ADDENDUM NO. 3

Perry Township Schools:
Southport High School Addition & Renovation Phase 1 (Activity Center Addition &
Wrestling/Center Plant Renovation)
971 E. Banta Road
Indianapolis, IN 46227

ADDENDUM NO. THREE

DATE OF ADDENDUM: February 12, 2026

Drawing Sheet Title: ELECTRICAL LIGHTING FIRST FLOOR PLAN – UNIT R

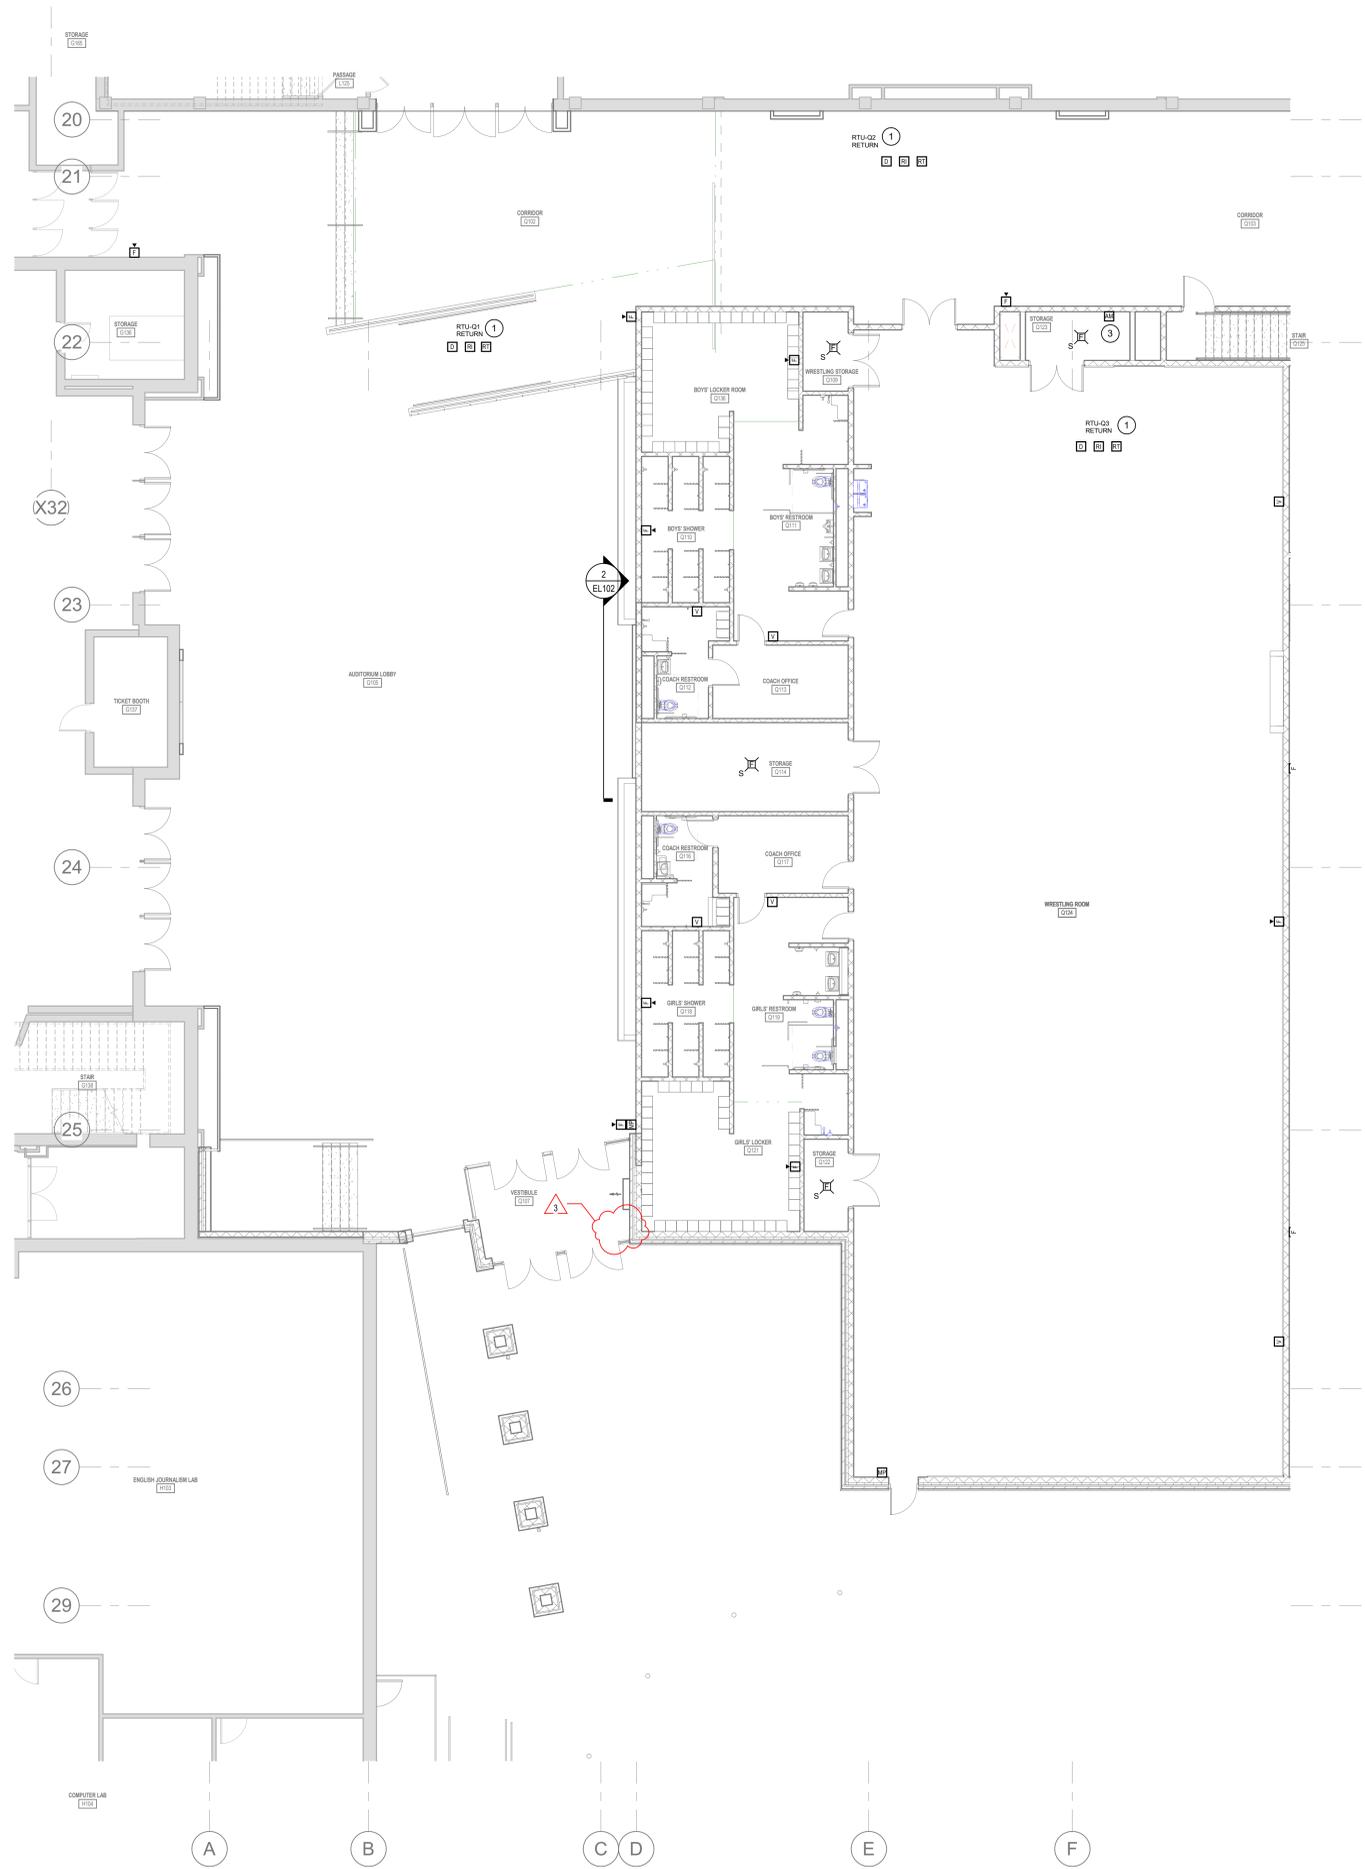
Change: Removed dimming from the weight room.
Change: Removed dimming from the activity center. Removed plan note 2 related to dimming requirements no longer needed.

ELECTRICAL FIRE ALARM FIRST FLOOR PLAN - UNIT Q
EF101

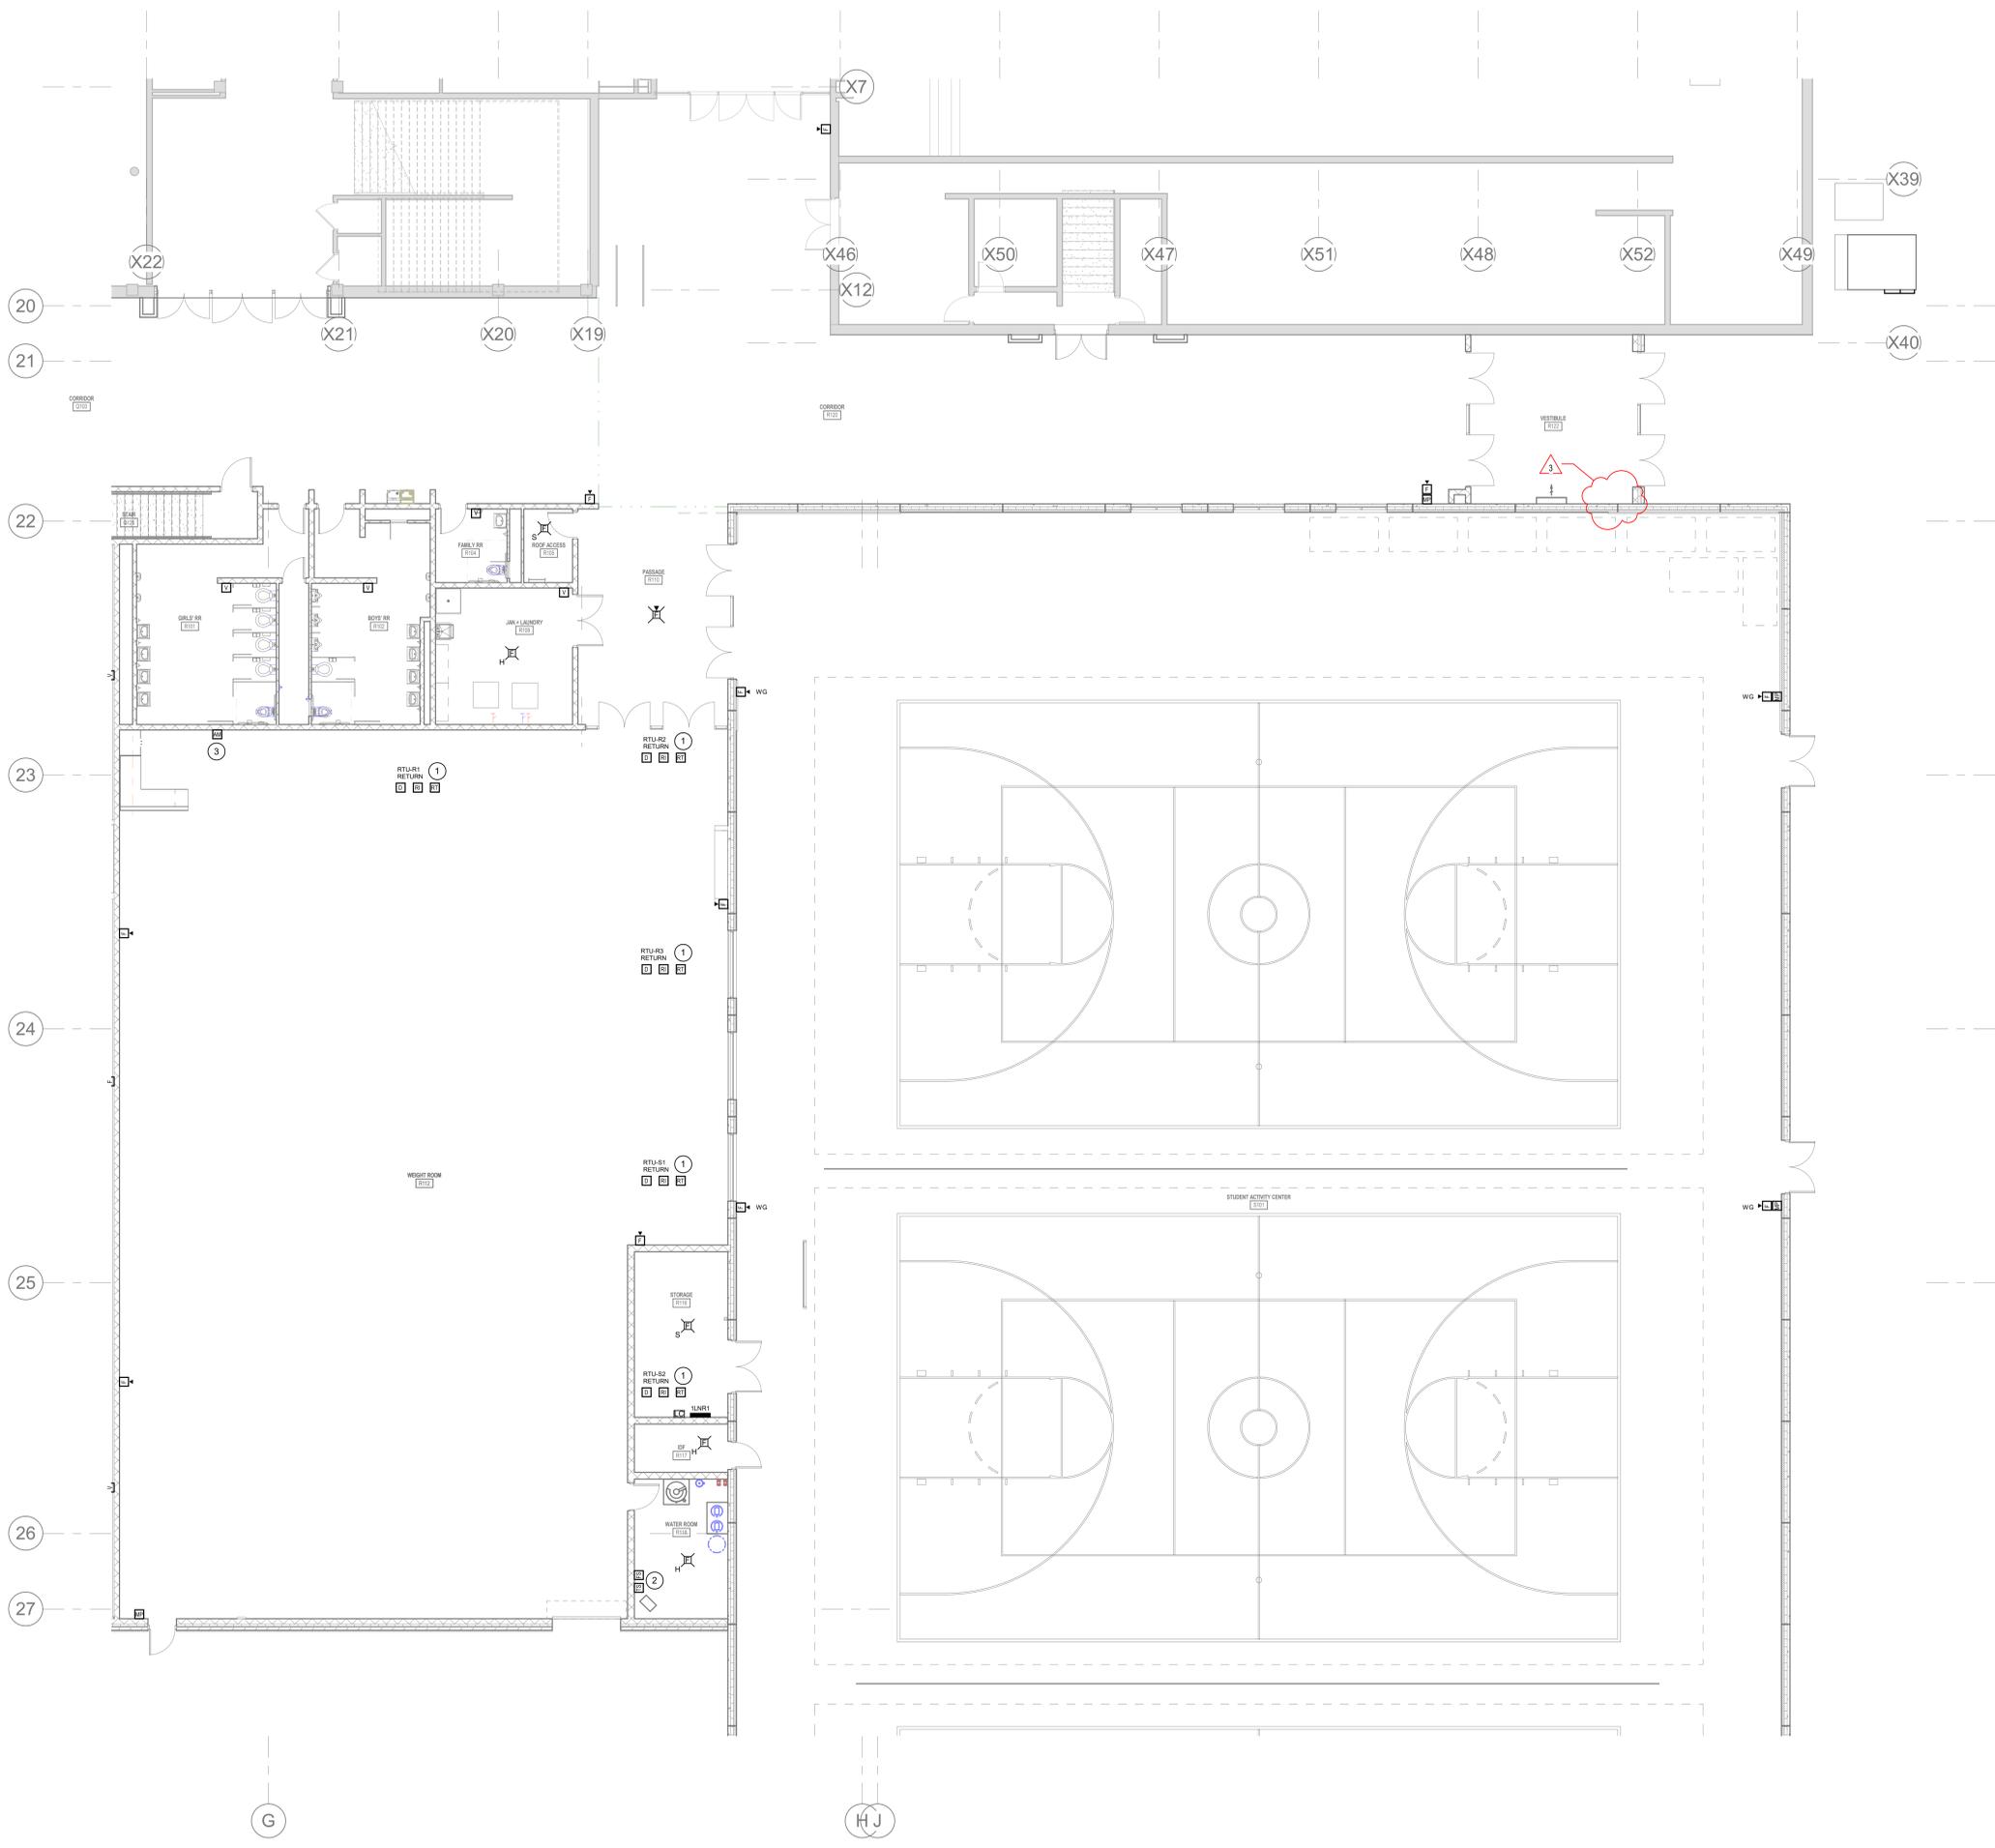
Change: Removed fire alarm annunciator from vestibule.

29. Drawing Sheet Number: E-601
Drawing Sheet Title: ELECTRICAL SCHEDULES

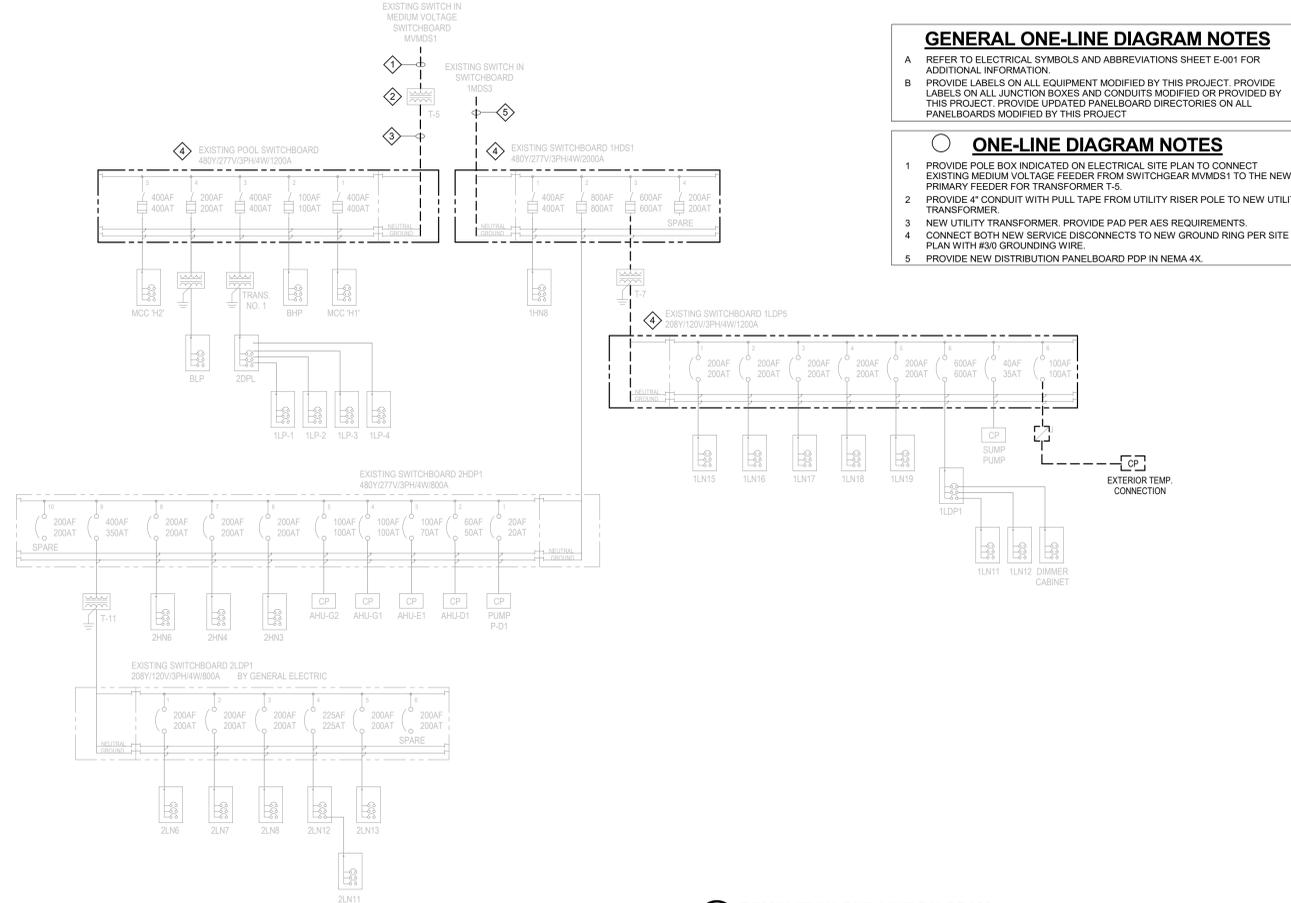
Change: Removed light fixture types L11 and L11-E.
